TECHNICAL INFORMATION

- Subject** ▶ Change of Flat Washer 10
- For Models** ▶ M101, M102, 1900B, 1901, 1902
- Country** ▶ All countries
- Description** ▶ Flat Washer 10 (Pt. No. 253796-4) has been replaced by Flat Washer 10 (Pt. No. 941251-5).

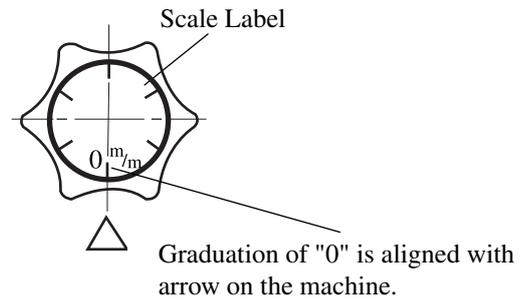
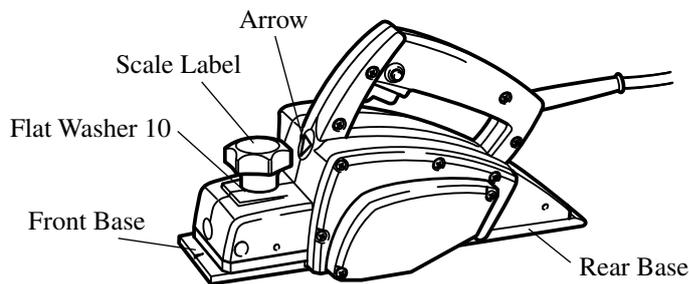
When replacing the current Flat Washer 10 (Pt. No. 253796-4) by the new one (Pt. No. 941251-5), always adjust depth of cut so that Front Base will be level with Rear Base. Then stick Scale Label on Knob so that graduation of "0" on the Scale Label will be aligned with arrow on the machine as shown below.

Item No.	Current part		Q'ty	I/C	New part		Q'ty	Note
See below.	Flat Washer 10 253796-4		1	No	Flat Washer 10 941251-5		1
